Report to the Future Melbourne (Planning) Committee

**Planning Permit Application: TP-2017-395
137-157 Adderley Street, West Melbourne**

16 October 2018

248-250 Rosslyn Street, first floor plan

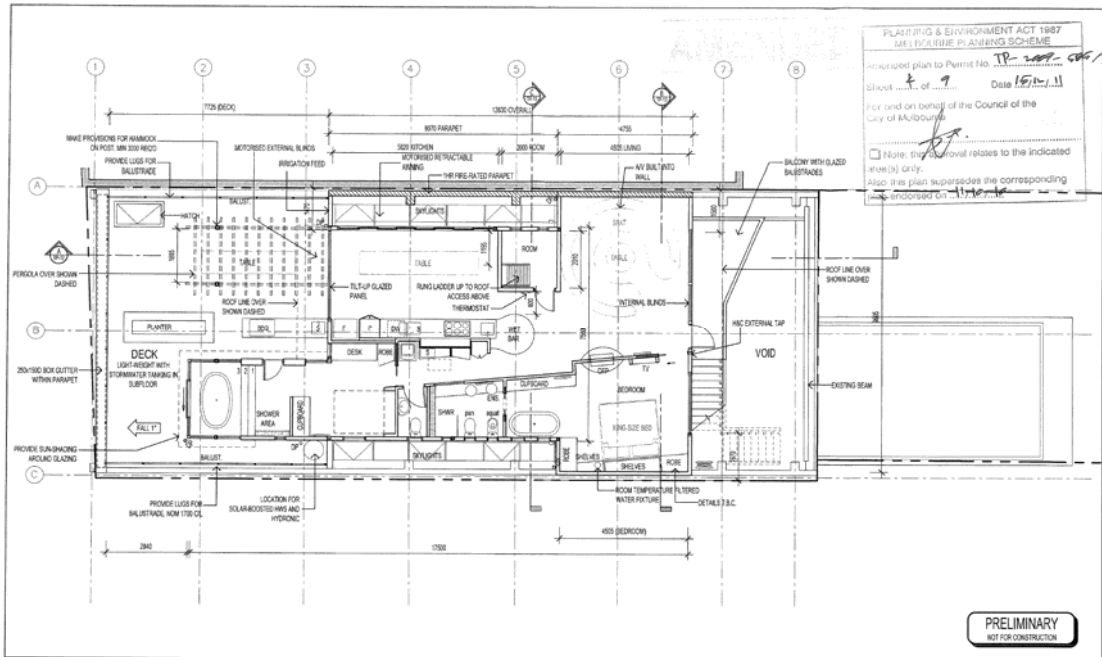
The endorsed plans for planning permit TP-2009-595/B show a warehouse on the ground floor and mezzanine, and a dwelling on the first floor with a balcony fronting Stanley Street and a rooftop terrace. The dwelling does not have any habitable room windows opposite the subject site, other than the kitchen and dining room windows behind the boundary wall, which are a secondary source of light.

248-250 Rosslyn Street, northeast elevation

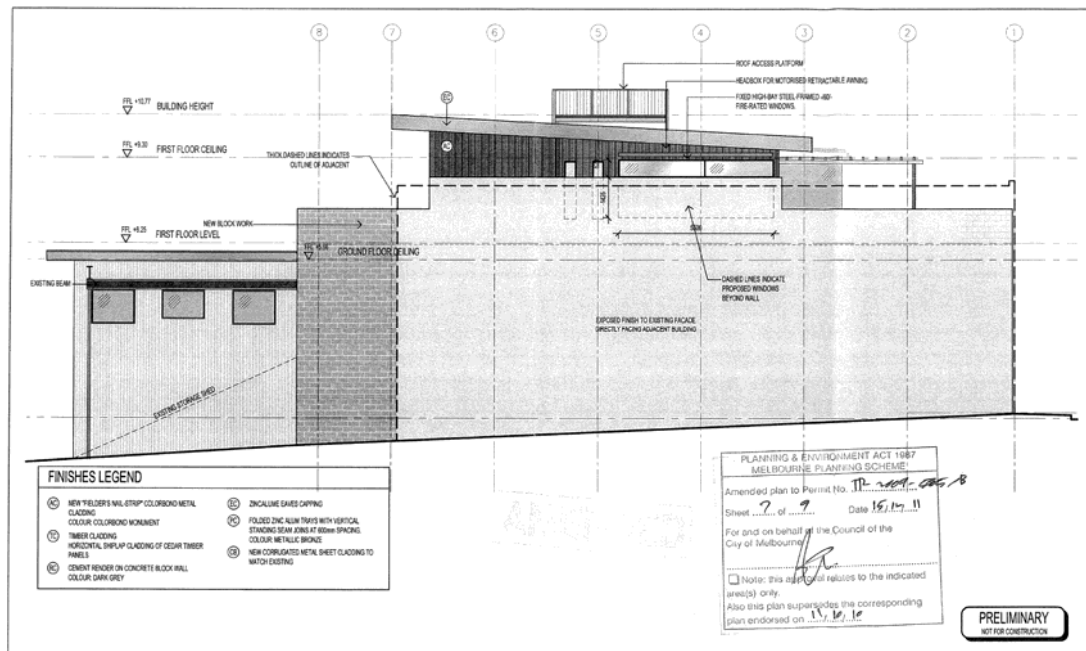
The proposed development has a four to five storey southwest boundary wall punctuated by two lightwells. The lightwells provide two distinct vertical breaks and measure approximately 9.4m wide x 7.3m deep (68.6m² in area) from upper ground level to level 3 (see southwest elevation in section 3 of this report).
